PLANNING & DEVELOPMENT COMMITTEE

APPLICATION NO: 17/0525/38 - Proposed revised restoration scheme following completion of coal extraction pursuant to Condition 8 of planning permission reference 13/0466, incorporating formation of a plateau for future development in accordance with Policy NSA8 of Rhondda Cynon Taf Local Development Plan, at opencast site, Tower Colliery. (Amended site and section plans, drainage details and new photo montages dated October 2017), Tower Colliery Railhead, Rhigos Mountain Road, Rhigos, Hirwaun, Aberdare, CF44 9UF

THE WELSH MINISTERS (THE NEATH TO ABERGAVENNY TRUNK ROAD (A465) (ABERGAVENNY TO HIRWAUN DUALLING AND SLIP ROADS) AND EAST OF ABERCYNON TO EAST OF DOWLAIS TRUNK ROAD (A4060) AND CARDIFF TO GLAN CONWY TRUNK ROAD (A470) (CONNECTING ROADS) (DOWLAIS TOP TO HIRWAUN)) AMENDMENT ORDER AND COMPULSORY PURCHASE ORDER 201-

Drawing title: **OBJECTION 081
 TOWER REGENERATION LTD
 NANT Y BWCH WATERCOURSE
 REALIGNMENT PROPOSAL**

Drawing number: **B2191100/OBJ081/003**

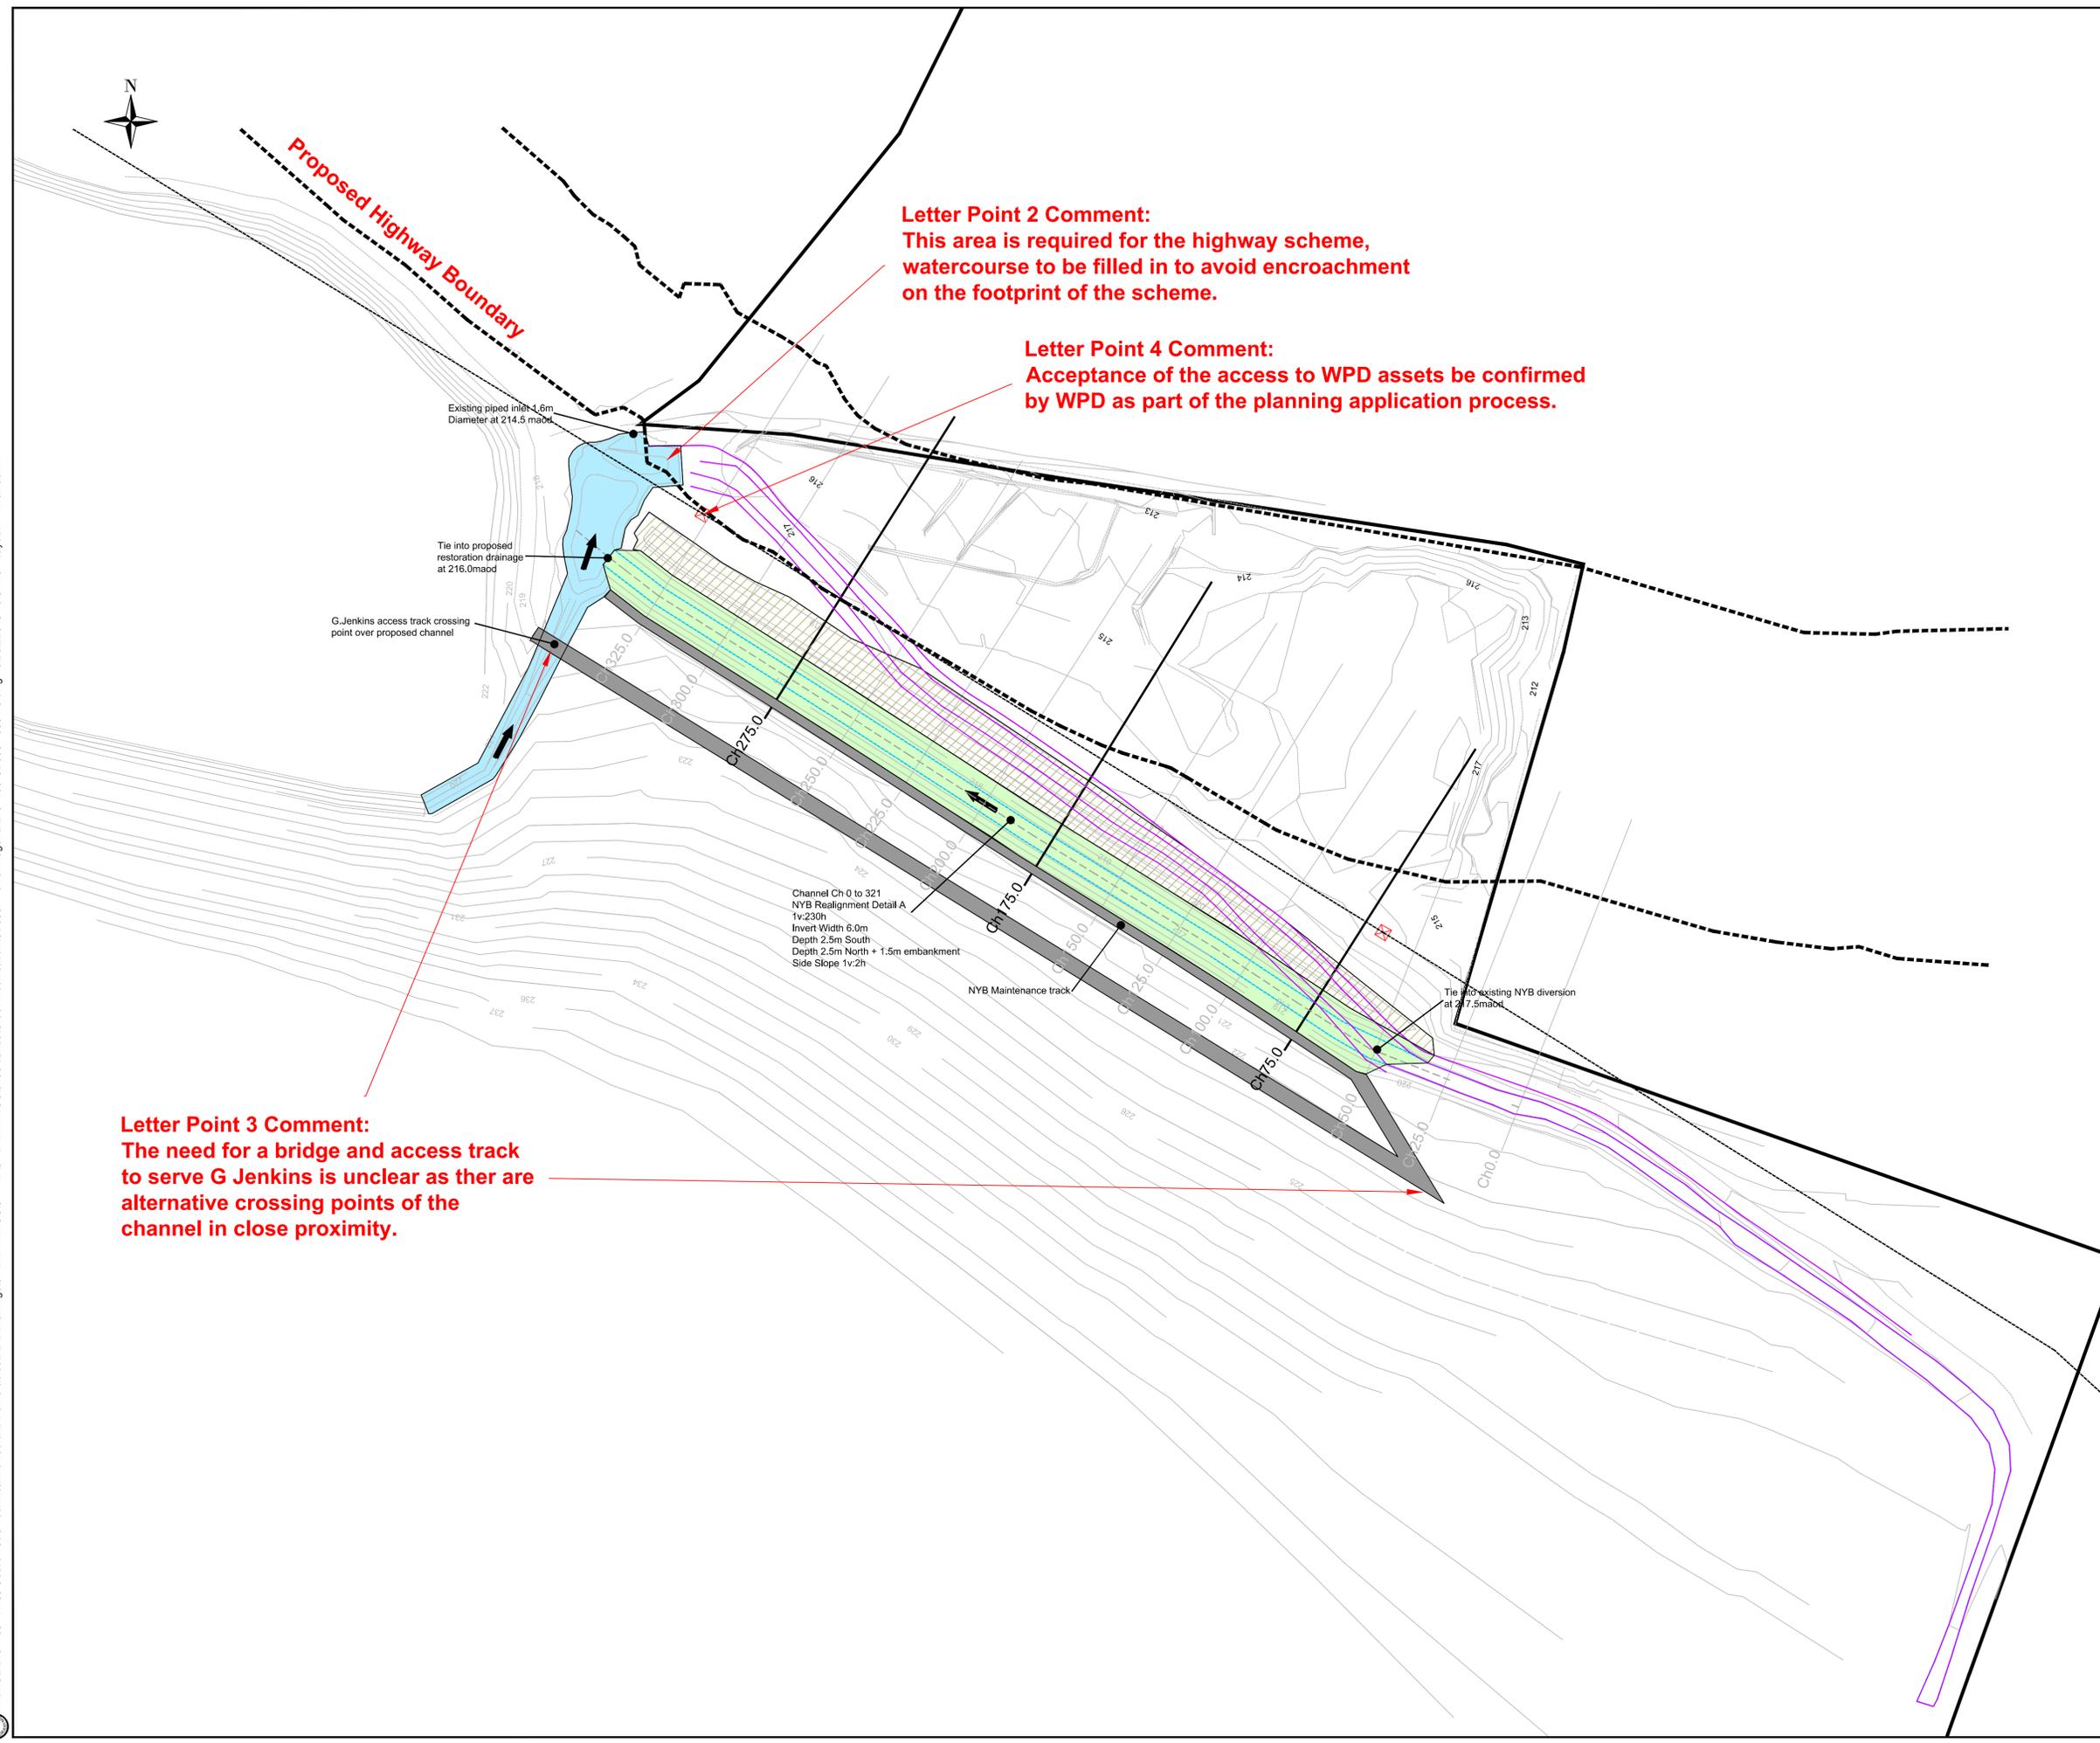
1. The route of the proposed re-alignment of the Nant Y Bwch watercourse, as set out in the aforementioned plan, is acceptable in terms of avoiding impact on the A465 scheme.
2. The length of the existing watercourse to be stopped up needs to be extended to avoid encroachment on the footprint of the scheme, see attached plan for details.
3. The need for a bridge and access track to serve G Jenkins is unclear as there are alternative crossing points of the channel in close proximity.
4. Western Power Distribution (WPD) will need to be consulted as part of your planning application to ensure access provision to their assets is acceptable. Access to WPD assets will not be granted from the Trunk Road.
5. The planning application (10/0292/10 granted 16 December 2011) clearly states that it was always the intention to return the diverted Nant Y Bwch watercourse to its

Letter Point 2 Comment:
 This area is required for the highway scheme,
 watercourse to be filled in to avoid encroachment
 on the footprint of the scheme.

Letter Point 4 Comment:
 Acceptance of the access to WPD assets be confirmed
 by WPD as part of the planning application process.

Letter Point 3 Comment:
 The need for a bridge and access track
 to serve G Jenkins is unclear as there are
 alternative crossing points of the
 channel in close proximity.

Subject to amendments relating to points raised above we approve the proposed re-alignment of the Nant Y Bwch watercourse. Please do not hesitate to get in touch if you wish to discuss any of the points raised in this letter.
